City of Prattville Historic Preservation Commission

**CITY OF PRATTVILLE
HISTORIC PRESERVATION COMMISSION
MINUTES**

**CERTIFICATE OF
APPROPRIATENESS**

327 S Washington Street – CA1107-01

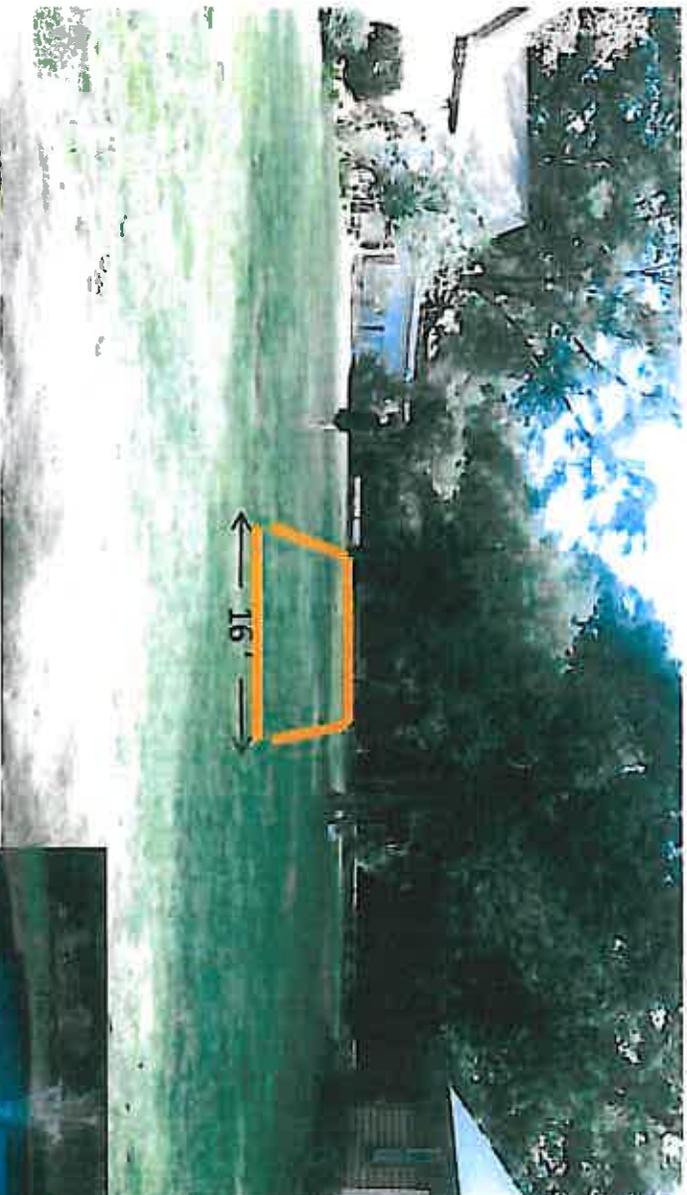
Build a 16x36 in-ground pool roughly centered in the area between the workshop and proposed patio addition.

The fence around the back yard will be erected on the property line to the north, even with the rear of the house on the west, approximately 14 feet off the south property line, and approximately 6 feet off the east to avoid building in a low drainage area. Fence will be constructed of brick columns and iron railing approximately 5 feet high.

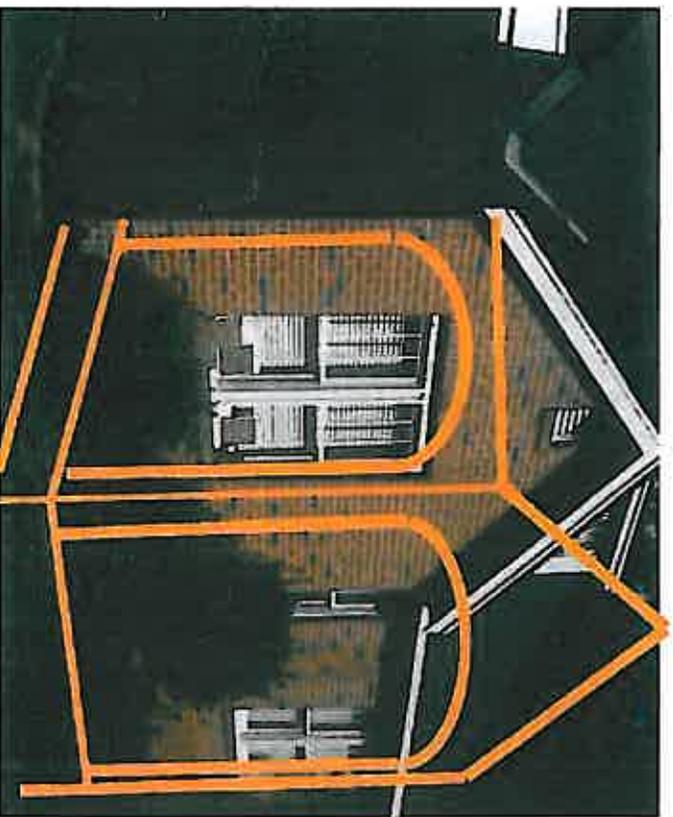
Build a 12x14 patio on the south end of the rear of the house, matching the protruding A-frame structure and extending out 12 feet to the south. New patio will be built with brick arches alike existing patio on the north side. Brick will be like existing.

Proposed new patio location
